Chapter 3: Affected Environment

Response to the <u>Remediation of the Moab Uranium Mill Tailings</u>, <u>Grand and San Juan Counties</u>, <u>Utah</u>, <u>Draft Environmental Impact Statement</u>

Illustration A - Minimum Extent of the Subsurface Channel Gravel Deposits as Mapped by Solomon and Gardner

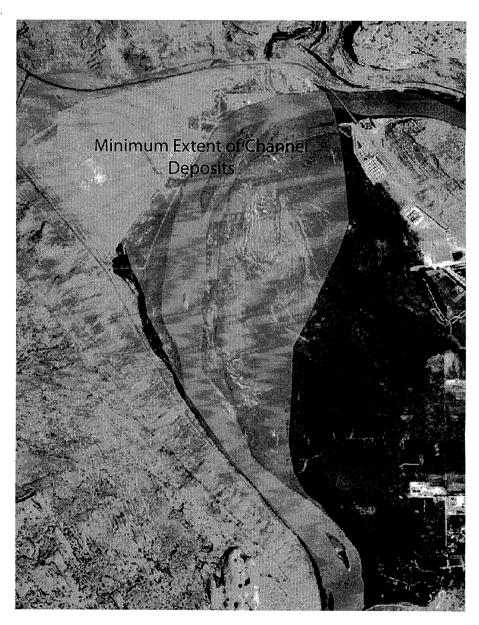
The core samples drilled on both sides of the river show that the Moab Mill Tailings rest on overbank deposits of very fine sands and silts that are 8 to 15 feet deep. Found beneath these fine soils is a large, continuous package of gravel and cobbles, up to 150 feet thick, that was deposited by the Colorado River during periods of large and very forceful floods. To determine the date of such past flood events, Solomon and Gardner used carbon -14 dating on organic matter found in the boreholes at depths of 24 and 30 feet. At 24 feet the organic matter was less

² Note: The Solomon/Gardner and USGS report illustrates that normal flood events will undermine the rip rap wall, erode away the fine silt and sand underlying the tailings, thus causing the tailings to spill into the Colorado River, questioning the effectiveness of any rip rap.
